Staff Report for Item 12a

To: Chairman Bryan Green and Historic Architectural Review
Commission Members

Application Number: H15-01-1359

Address: #525 Olivia Street

RENOVATIONS
 PROPOSED ELEVATIONS

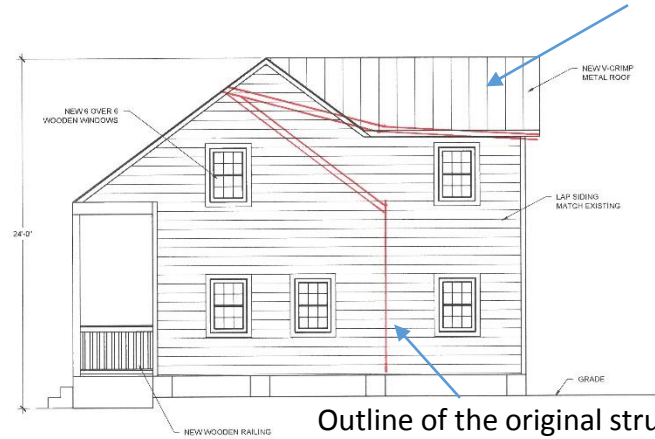
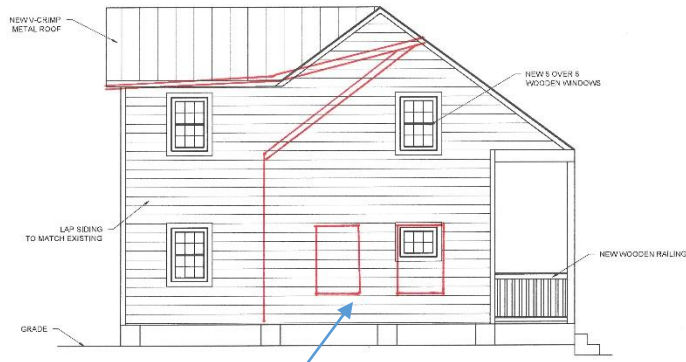
Ridge of the roof is expanded.

More appropriate location of new posts

The proposed addition will overwhelm the historic house.

Outline of the original structure will be removed.

Original window openings to be removed.
